Access Compliance Report

Public Rights-of-Way

(Curb Ramps)

Intersection ID: N/A	Main Street: REVERDY LN	Cross Street: SHADOW_FOREST_DR	Location: SW
ADA ID: 7EB466AB809E	Ramp Type: PerpDiag	Initial Pass/Fail: Fail	Overall Compliance: No
			Severity Score: 33.75

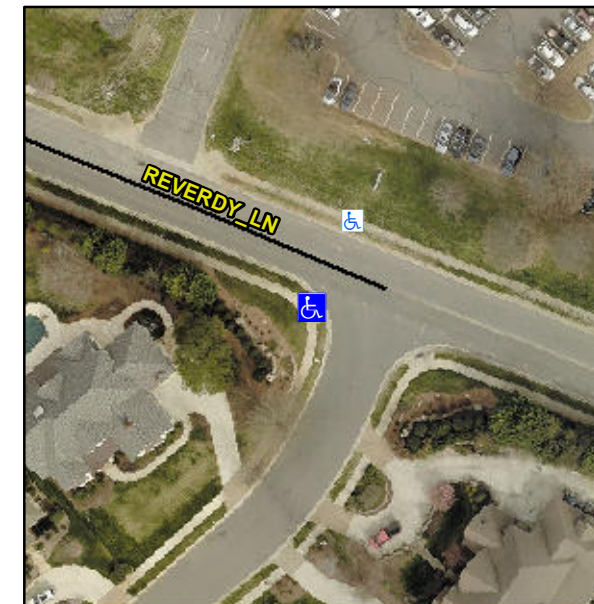
Not Found, R304.5.1, R304.5.3

Compliance	Description	Data	Compliance	Description	Data
N/A	Ramp Length (in)	120.0	Yes	Ramp Slope (%)	5.0
No	Ramp Width (in)	44.0	No	Ramp XSlope (%)	12.2
N/A	Flare Type LT	N/A	N/A	Flare Type RT	N/A
N/A	Flare Slope LT (%)	N/A	N/A	Flare Slope RT (%)	N/A
N/A	Flare Traversable LT?	N/A	N/A	Flare Traversable RT?	N/A
N/A	Landing Length (in)	N/A	N/A	DWS Provided?	N/A
N/A	Landing Width (in)	N/A	N/A	DWS Contrast?	N/A
N/A	Landing Slope (%)	N/A	N/A	DWS Length (in)	N/A
N/A	Landing X Slope (%)	N/A	N/A	DWS Full Width?	N/A
N/A	Landing Curb? (Y/N)	N/A	N/A	DWS Offset (in)	N/A
N/A	Shared Landing?	N/A			
N/A	Gutter Ponding?	N/A	N/A	Gutter Slope (%)	N/A
N/A	Gutter Lip Ht (in)	N/A	N/A	Gutter X Slope (%)	N/A
N/A	Painted X Walk1?	No	N/A	Painted X Walk2?	No
	X Walk 1 Direction	To SE		X Walk 2 Direction	To NE
N/A	X Walk 1 Width (in)	N/A	N/A	X Walk 2 Width (in)	N/A
	X Walk 1 Slope (%)	4.4		X Walk 2 Slope (%)	4.7
	X Walk 1 X Slope (%)	5.5		X Walk 2 X Slope (%)	6.4

Remove & Replace Curb Ramp With Two New Directional Ramps or Equivalent.
